INSERTION INSTRUCTIONS FOR AMENDMENT 17

Correction pages to the Preliminary Safety Analysis Report (Volumes 1-9) are identified by "Amendment 17, 2/79" and are printed on green stock.

FIG. 3.8.1-25a
EMERGENCY AIR CONNECTION
AND DOOR SEALS OF
PERSONNEL ACCESS LOCK
WISCONSIN UTILITIES PROJECT
PRELIMINARY SAFETY ANALYSIS REPORT

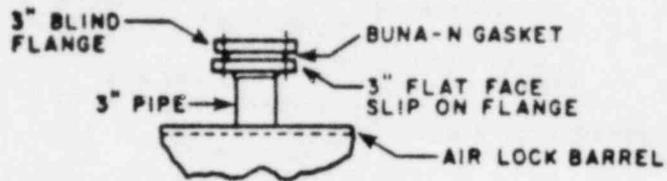
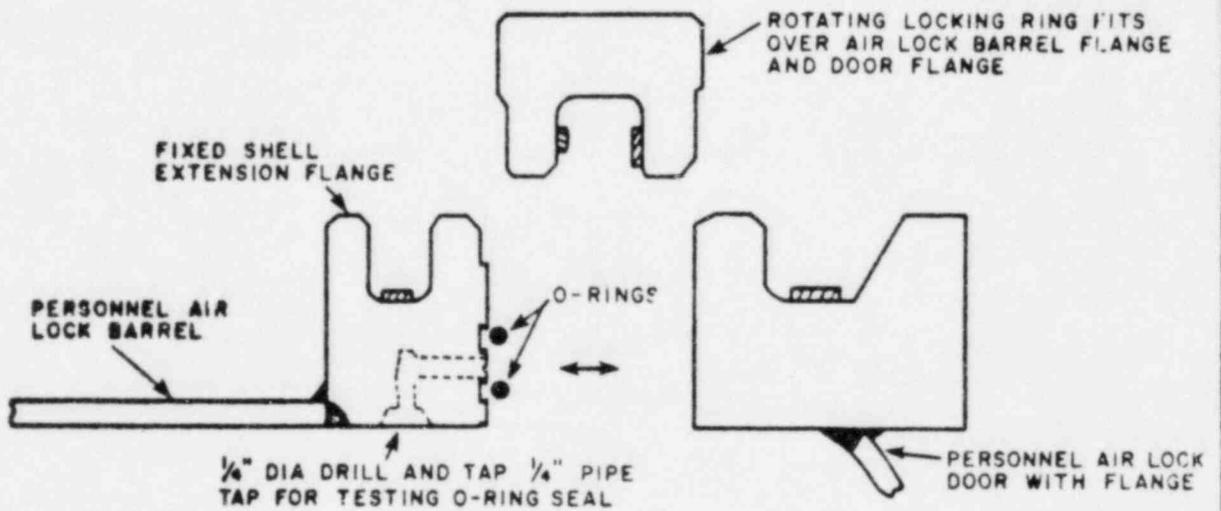
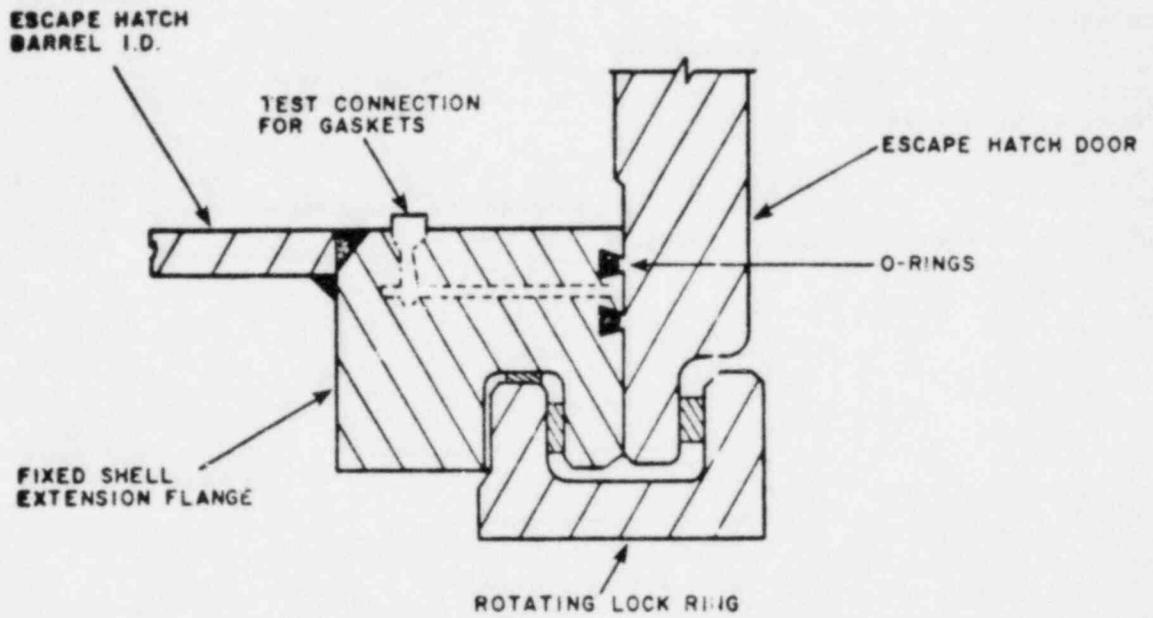
17 | Views of typical personnel air lock design and identification of its electrical and mechanical penetrations are shown on Fig. 3.8.1-25, 3.8.1-25a, and 3.8.1-25b. Schematics of testing provisions for the pressure testing of the personnel air lock and air lock seals are shown on Fig. 3.8.1-25b. Detail 1 of Fig. 3.8.1-25a depicts a 3-in. emergency air connection which is also used for pressurization of the air lock for the pressure test and leak test. On the same figure, detail 2 shows the fixed shell extension flange, lock ring, and door flange out of position. The locking ring fits over the lips of the shell flange and door flange compressing the o-rings for leaktightness. Also shown in detail 2 is the 1/4-in. tap hole for periodic testing of the o-rings. Fig. 3.8.1-25b shows the detail of the door seals for the escape hatch. The locking ring fits over the lips on fixed shell extension flange and door flange compressing the gaskets. The test connection for pressurization of these gaskets is also shown in detail 3.

FIG. 5.5-3
 MODEL F STEAM GENERATOR
 WISCONSIN UTILITIES PROJECT
 PRELIMINARY SAFETY ANALYSIS REPORT

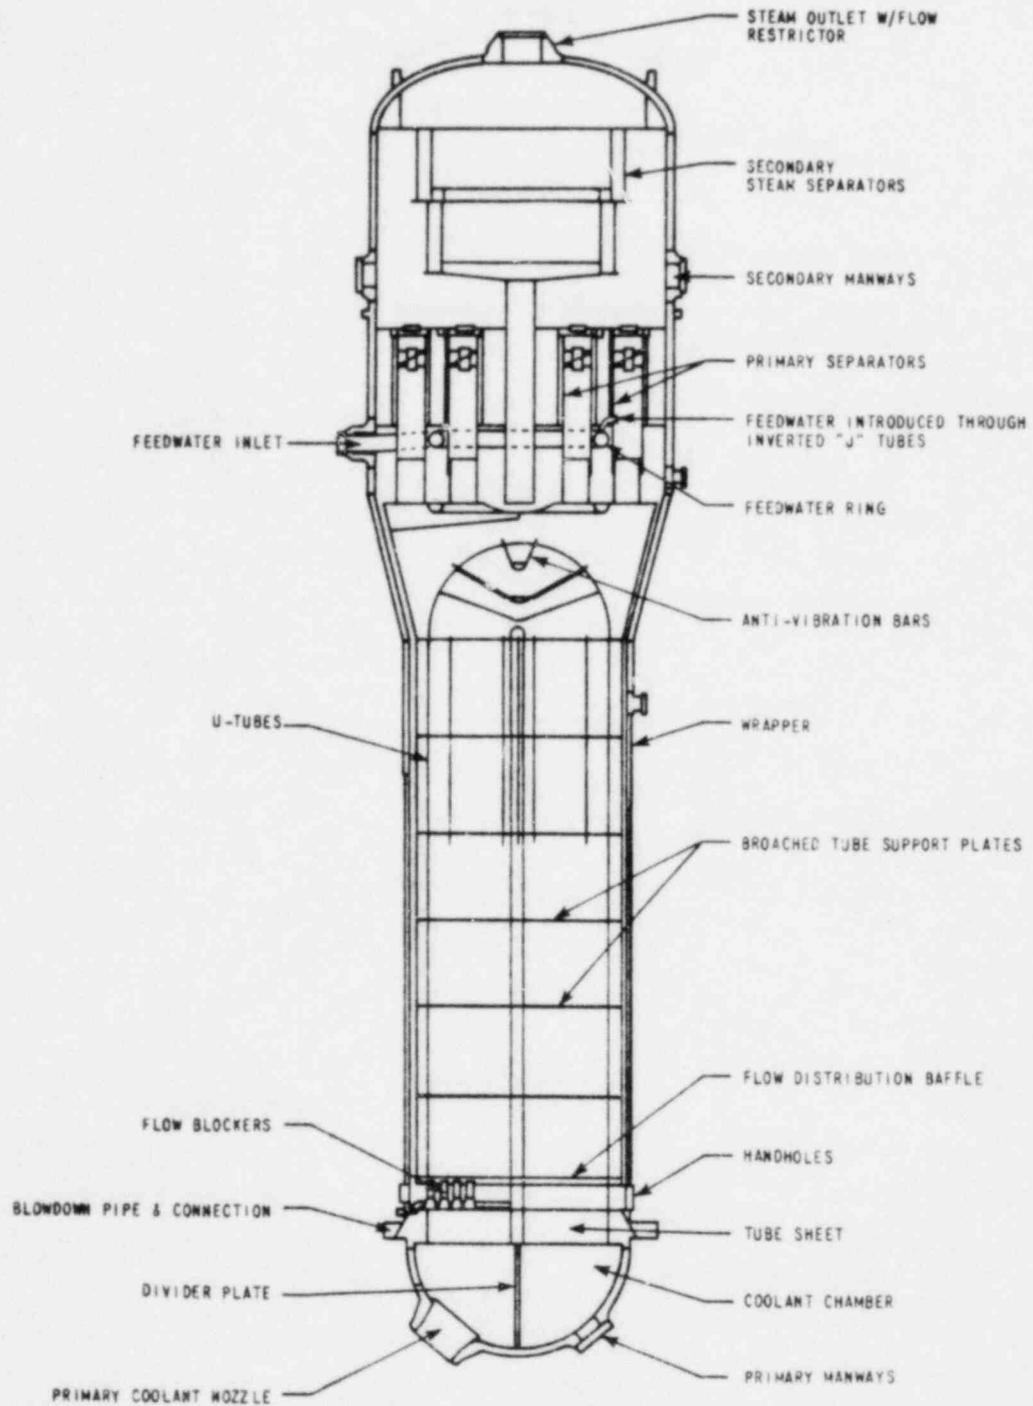
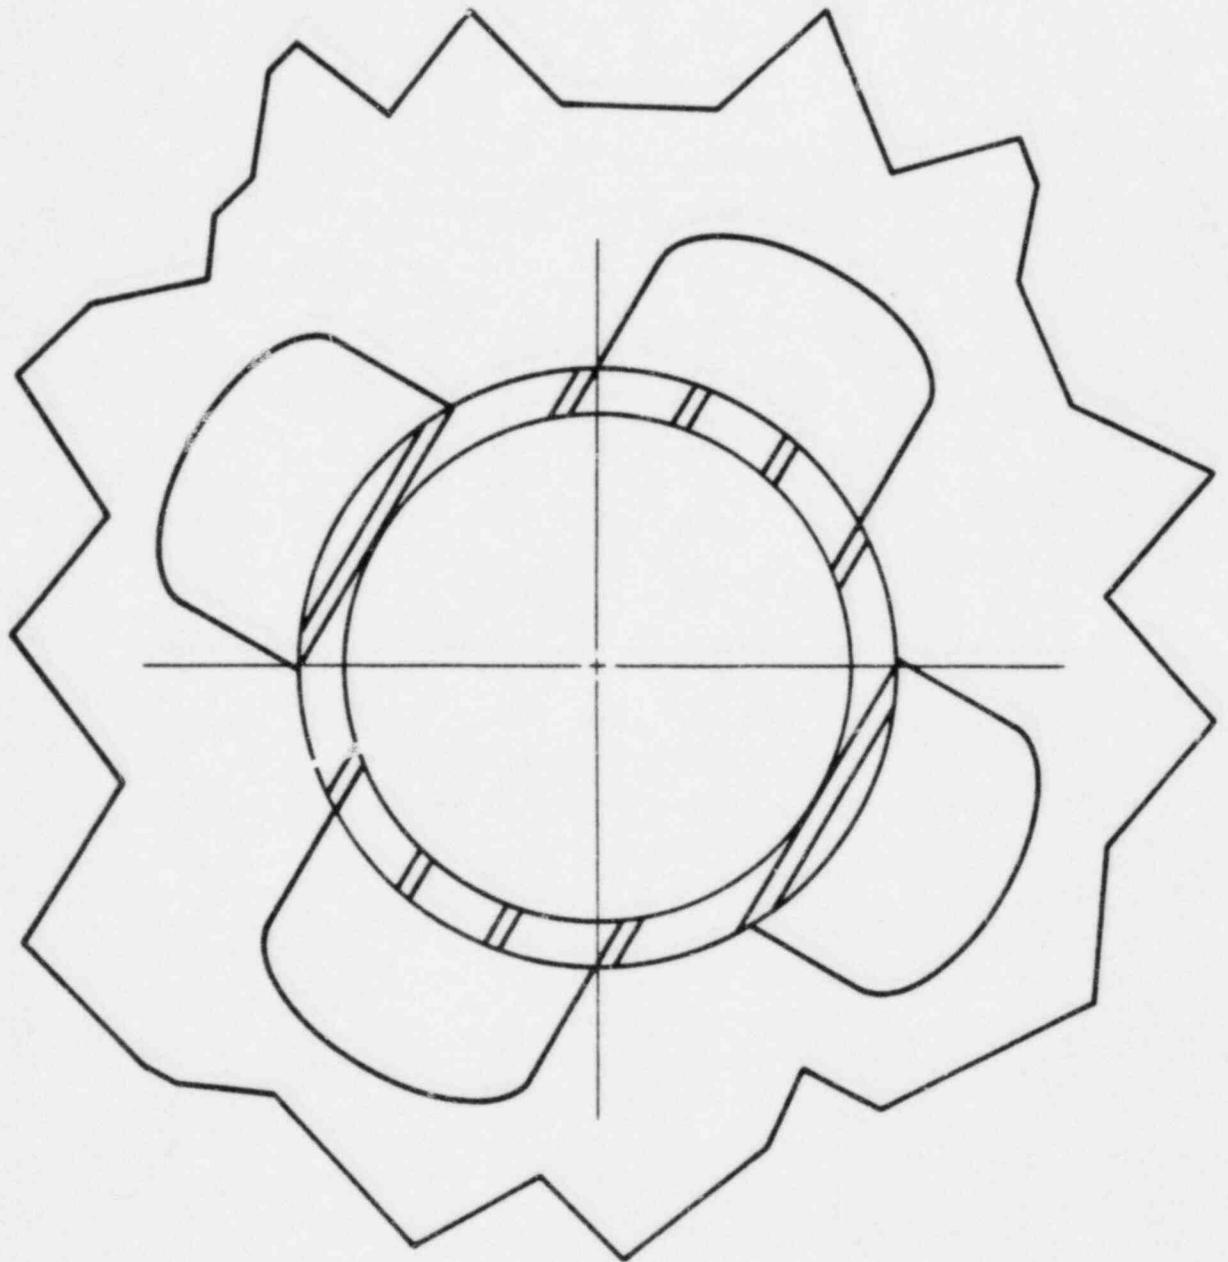
Additional measures are incorporated in the Model F design to prevent areas of dryout in the steam generator and accumulations of sludge in low velocity areas. Modifications to the wrapper have increased water velocities across the tube sheet. A flow distribution baffle is provided which forces the low flow area to the center of the bundle. Increased capacity blowdown pipes have been added to enable continuous blowdown of the steam generators at a high volume. The intakes of these blowdown pipes are located below the center cut-out section of the flow distribution baffle in the low velocity region where sludge may be expected to accumulate. Continuous blowdown provides maximum protection against inleakage of impurities from the condenser.

FIG. 6.2.1-55
 CONTAINMENT PRESSURE
 MAIN STEAM LINE BREAK
 FAILURE OF ONE ESF TRAIN
 WISCONSIN UTILITIES PROJECT
 PRELIMINARY SAFETY ANALYSIS REPORT

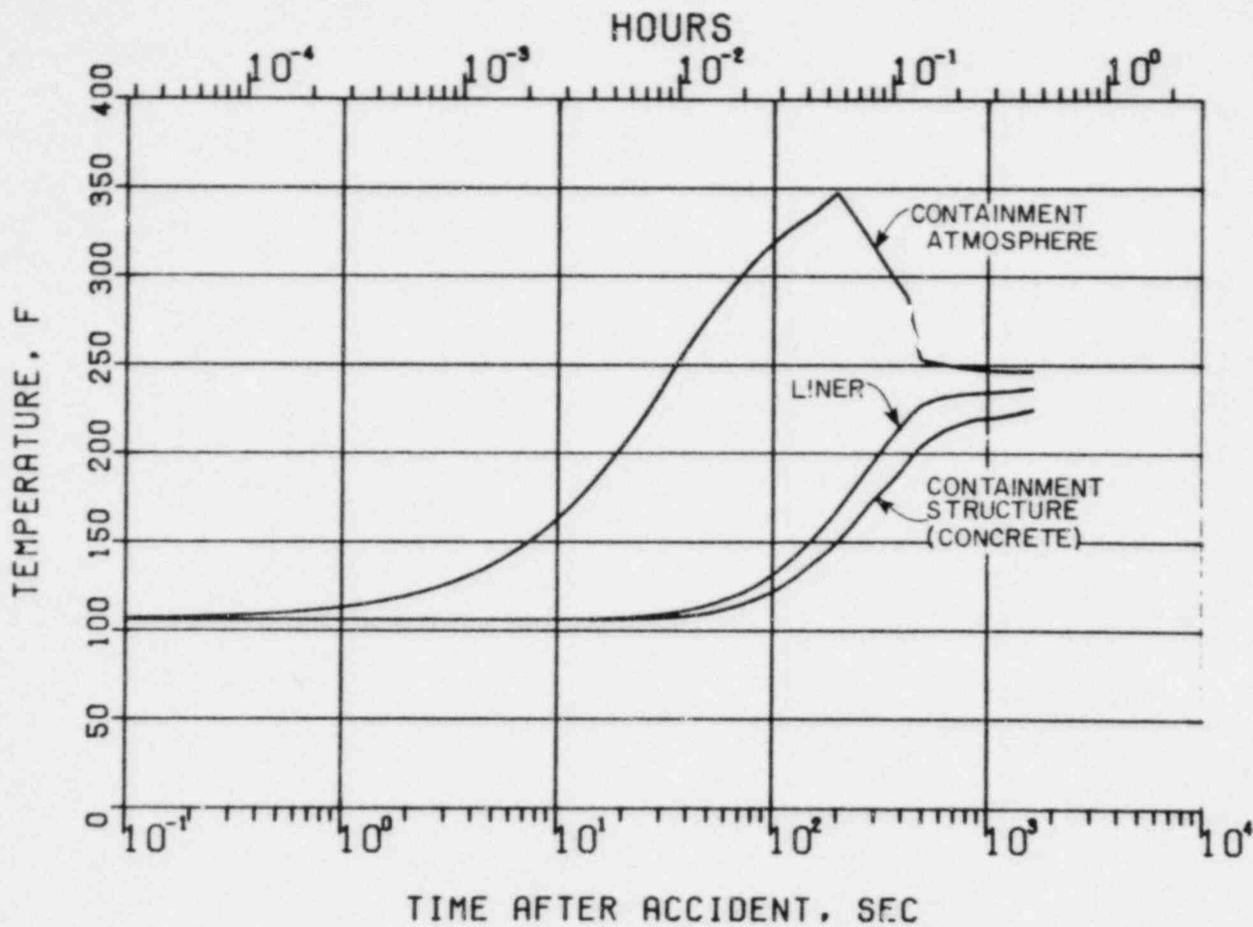
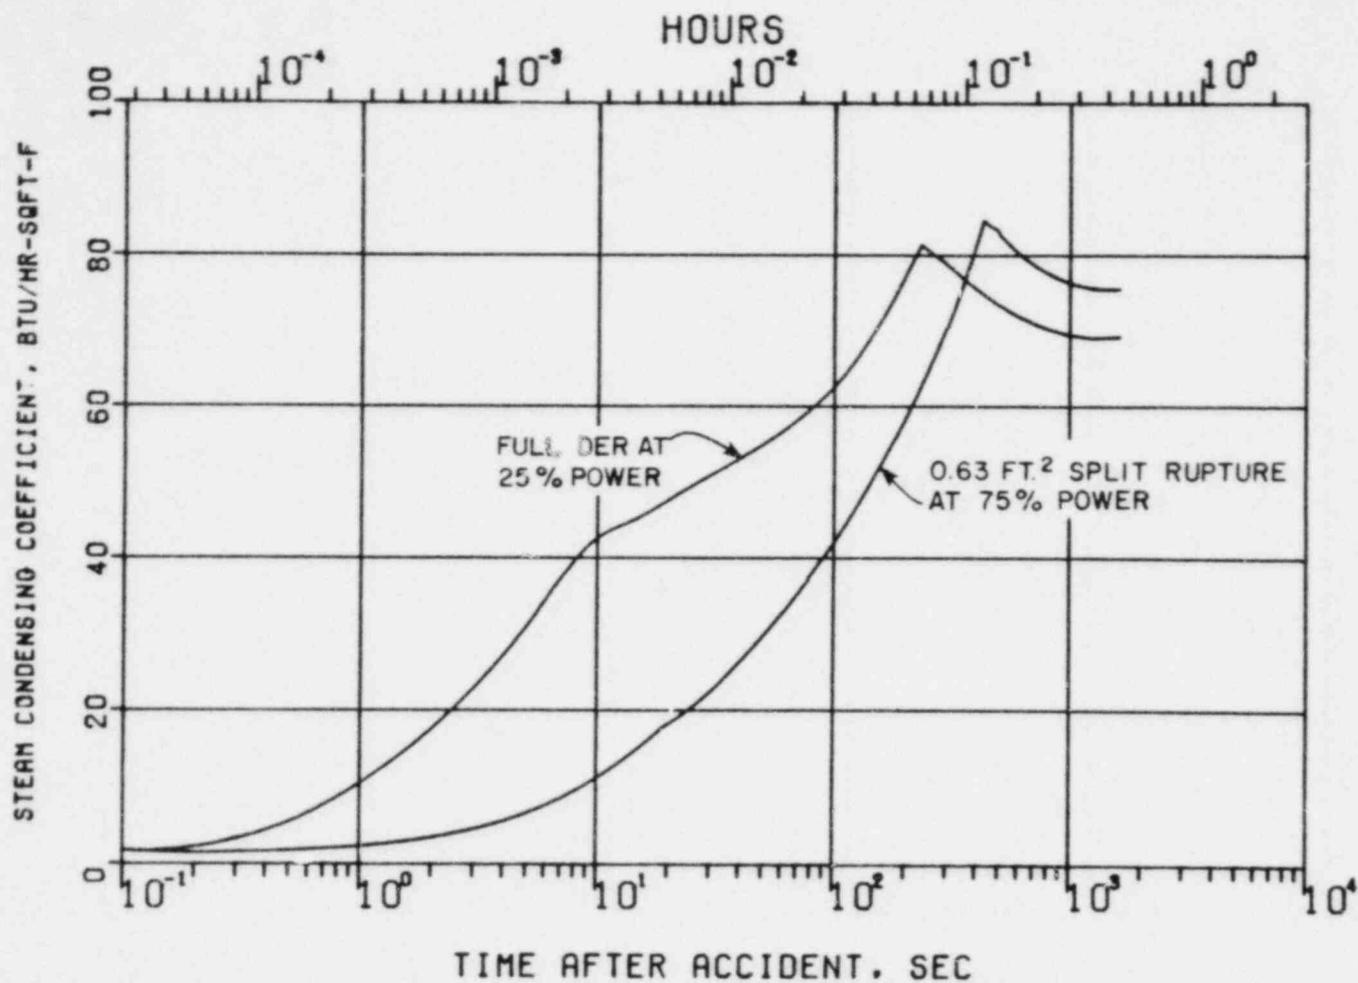
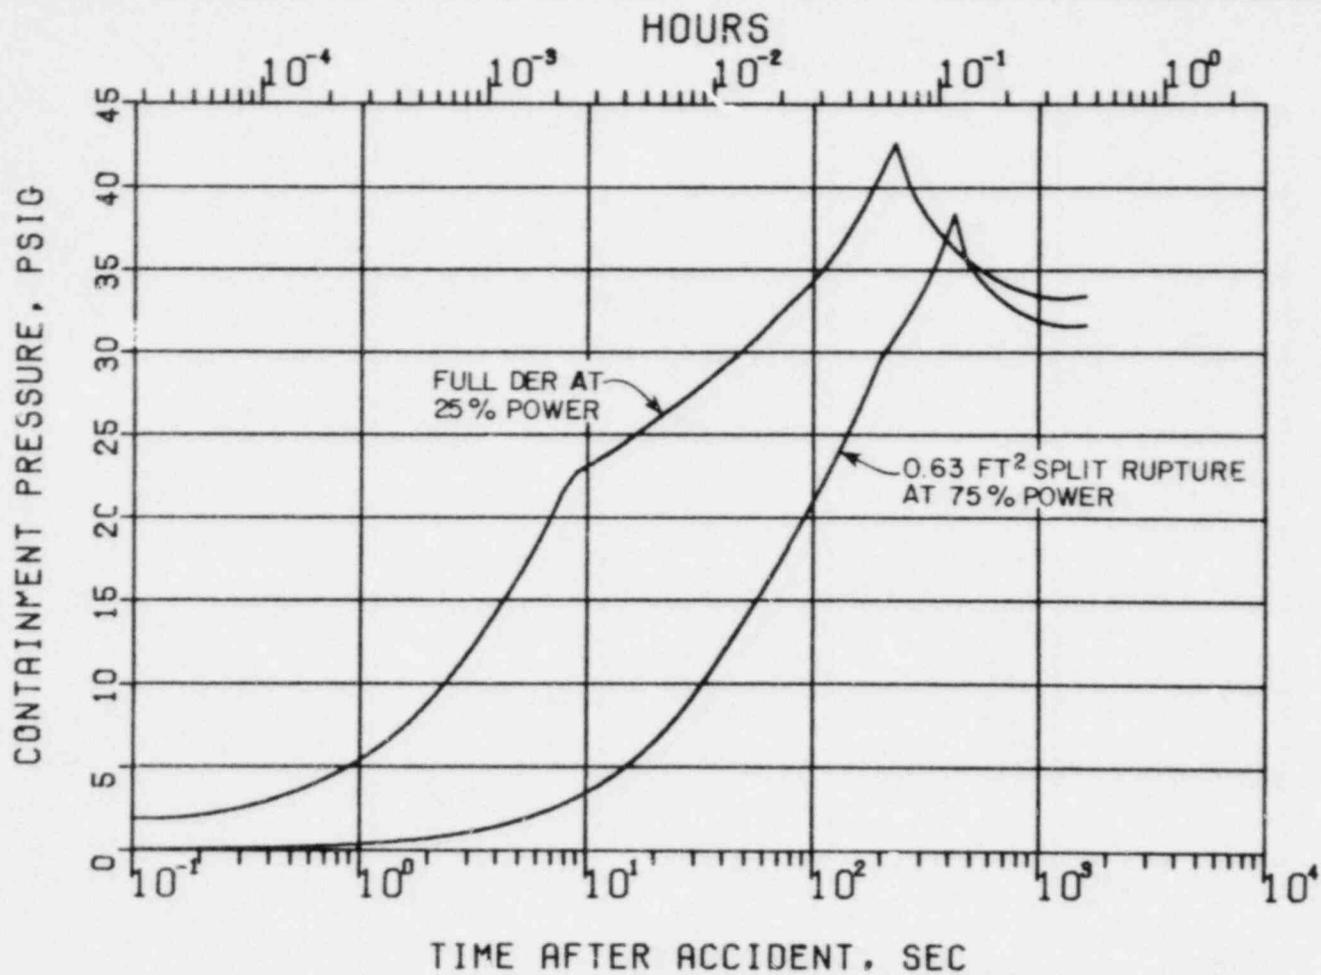
(0.63 ft² split at 75 percent power, ESF train failure, 14.7 psia
initial containment pressure) are shown on Fig. 6.2.1-55. The
maximum calculated containment pressure is less than the
containment design pressure by more than 10 percent. The
8 | containment atmosphere, liner, and concrete temperatures for the
17 | limiting temperature case are shown on Fig. 6.2.1-53. As shown
17 | on this figure, the containment liner and concrete temperatures
17 | do not exceed the containment liner design temperature of 275 F
17 | while the atmosphere temperature reaches 348 F. For this
17 | accident, the peak calculated containment liner and concrete
temperatures are 237 F and 225 F, respectively. The liner
temperature is taken at the inside surface while the concrete
temperature is taken at the liner-concrete interface. The
17 | maximum concrete and steel temperatures inside the containment
are 237 F and 257 F, respectively.
